PLANNING REPORT

Planning & Zoning Commission

Mount Carmel Health System 24-146AFDP

Address	4105 Emerald Parkway
Proposal	Proposal for an Amended Final Development Plan to modify previously approved signs and new chapel building uplighting. The +/- 35-acre site is zoned PUD: Mount Carmel Hospital Northwest and is located northwest of the I-270 and Sawmill Road interchange.
Request	Request for review and approval of an Amended Final Development Plan (AFDP) under the provisions of Zoning Code Section 153.055(B).
Zoning	Planned Unit Development (PUD) – Mount Carmel Hospital Northwest
Planning Recommendation	<u>Approval of an Amended Final Development Plan</u>
Next Steps	Upon approval of the AFDP, the applicant may apply for permits through Building Standards.
Applicant	Kyle Maiser
Case Manager	Christopher Will, AICP, Senior Planner cwill@dublin.oh.us 614.410.4498

Perspective view of chapel and cross from community wellness green, view to east.

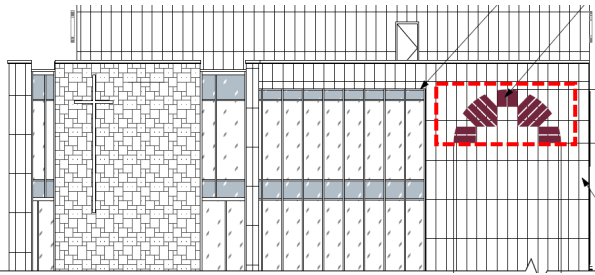
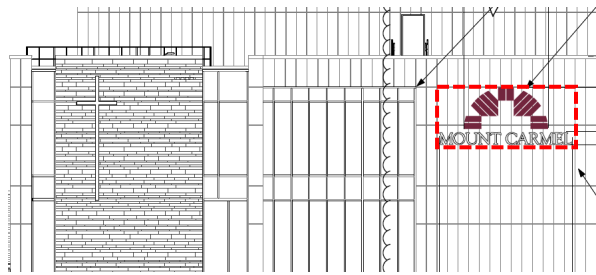
A single in-ground, Hunza Safe Touch light fixture is proposed for the base of the stone chapel and is proposed to be angled so as to illuminate the cross at night. The chapel is located within the northwest portion of the hospital building, south of the attached medical office building. The cross is attached to the top of the chapel, therefore backlighting or halo lighting would not be practical. The fixture emits light with a color temperature between 2700K (warm) and 4000k (natural light) which is consistent with the development text. The proposed light fixture is located in the interior of the site and is approximately 500 FT from the closest residential dwelling and 700 FT from the closest public right-of-way. The medical office building, hospital and perimeter landscaping provide adequate screening from public view. The chapel and cross provide a terminus and visual interest of the vista from the primary entry drive and community wellness green - a central open space and primary organizing feature of the campus. Lighting of the chapel and cross would further highlight this feature. The development text requires Commission approval for any building uplighting.

5. Adequate lighting for safe and convenient use of the streets, walkways, driveways, and parking areas without unnecessarily spilling or emitting light onto adjacent properties or the general vicinity	Criterion Met: A single in-ground light is proposed at the interior of the site, screened from adjacent properties and rights-of-way by the medical office building, hospital building and perimeter landscaping
